SAFETY EVALUATION BY THE OFFICE OF NUCLEAR REACTOR REGULATION

REGARDING RESULTS OF THE REINSPECTION OF THE CORE SHROUD

NIAGARA MOHAWK POWER CORPORATION

NINE MILE POINT NUCLEAR STATION, UNIT 1

Figure 1-1 NMP1 Shroud Weld Locations, Cross Sectional View

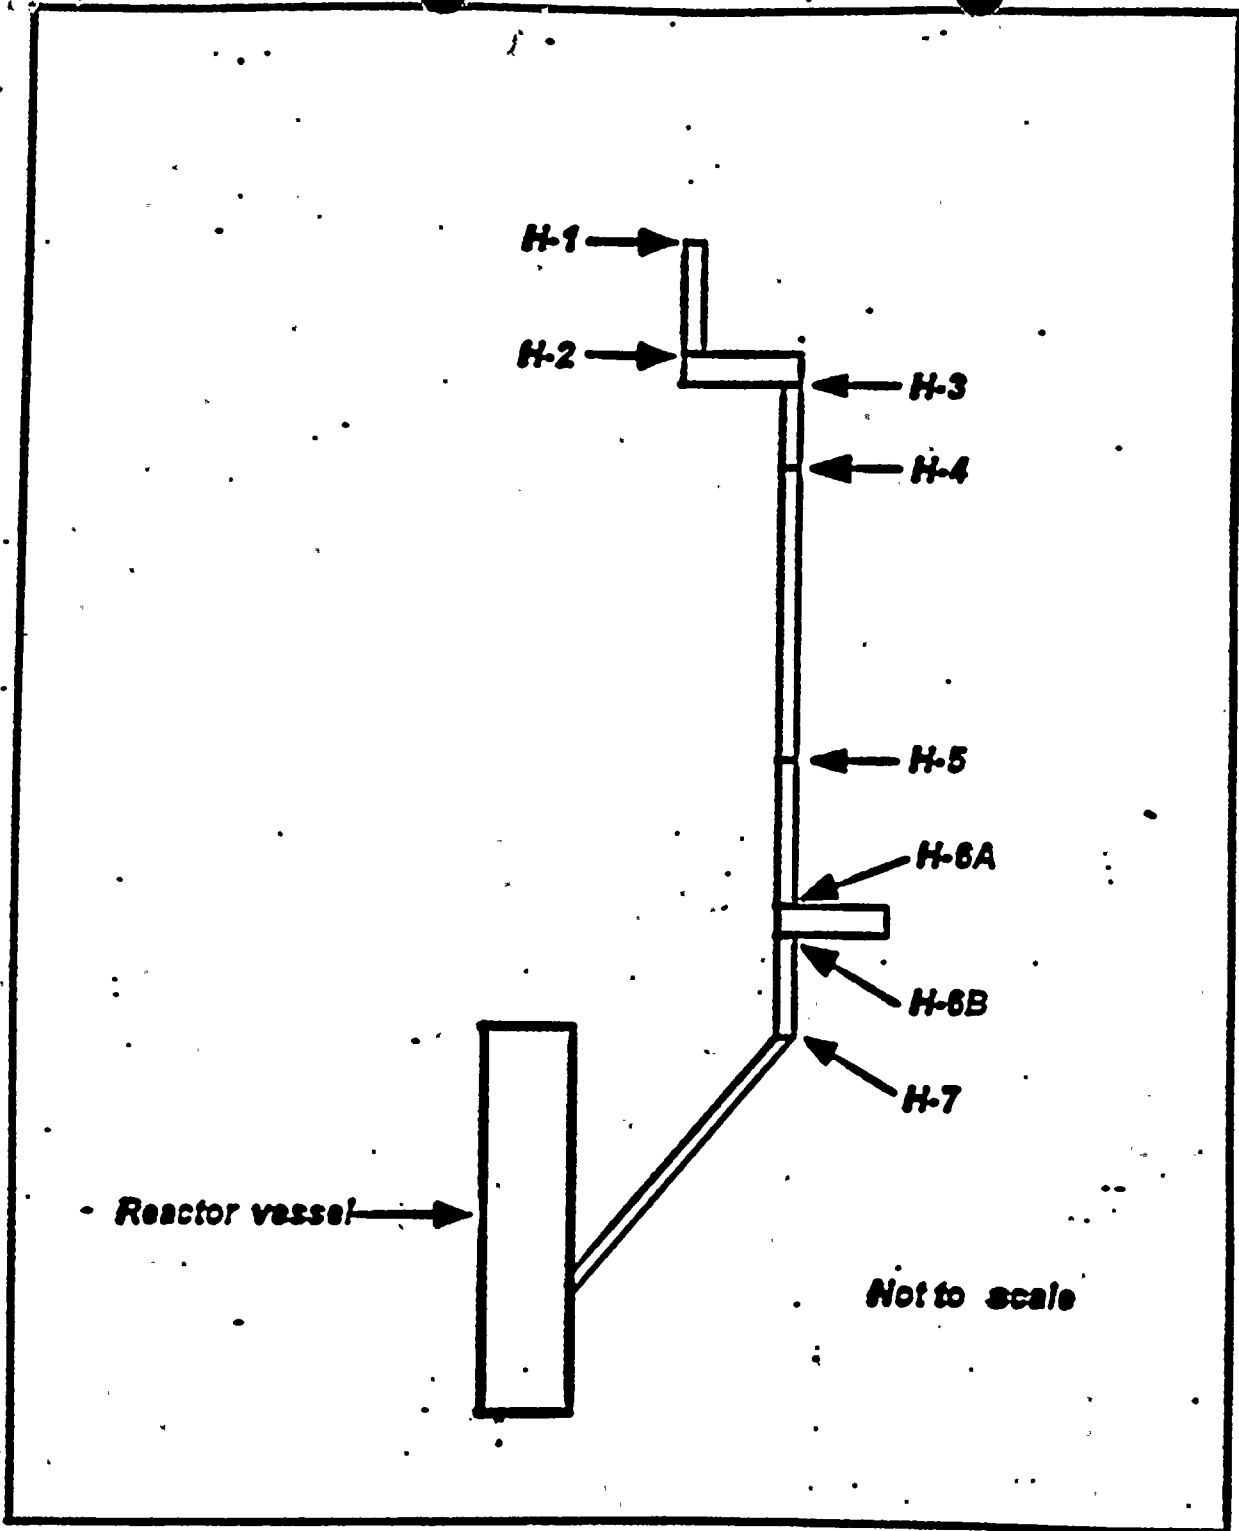
Figures 1-1 and 1-2 show the location of the shroud welds.¹ Table 2-2 shows the findings for vertical weld inspections. NMPC did not present a table of findings for the horizontal welds, but provided examination indication maps

Figure 1-2 NMP1 Shroud Weld Locations

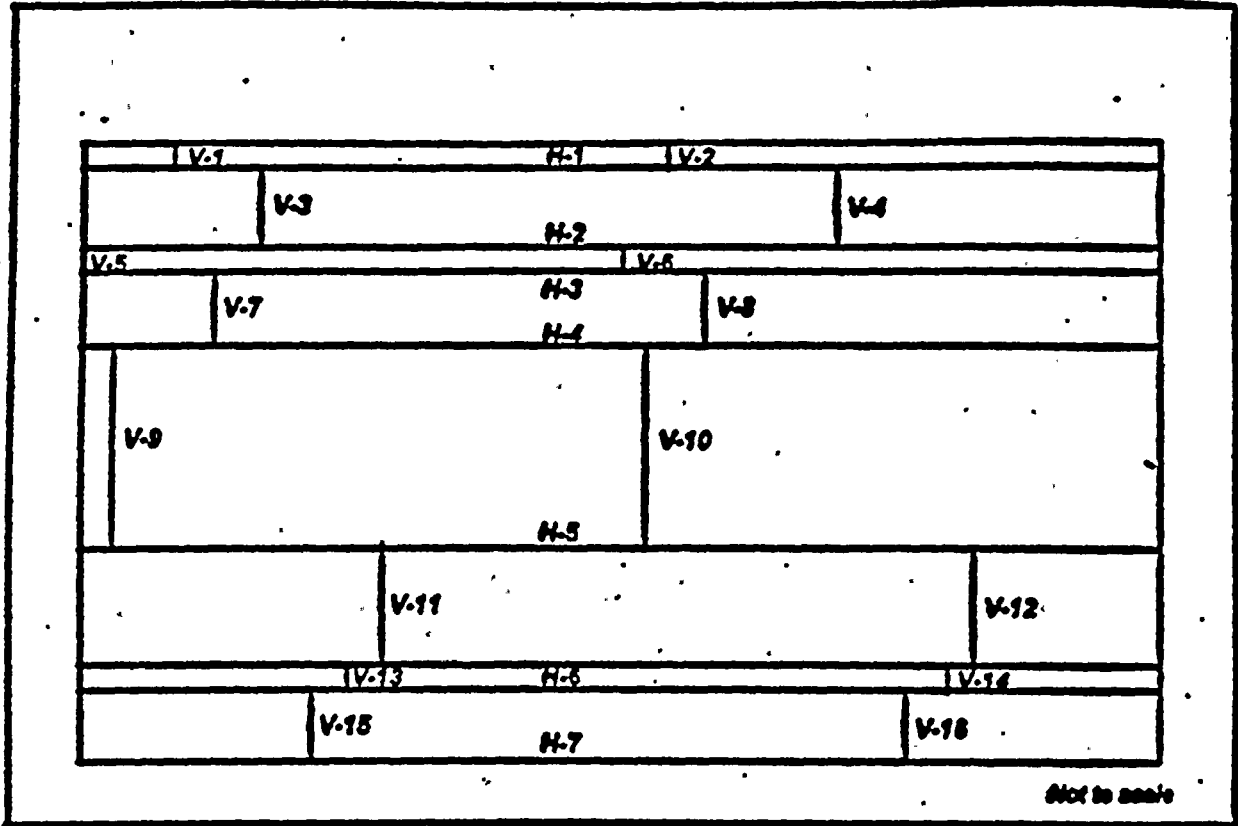
The ring segment welds (labeled in Figure I-2 as V5 and V6) were excluded from the vertical welds requiring inspection based on a GE analysis of the ring segment welds submitted to the NRC staff for review by letter dated February 7, 1997.
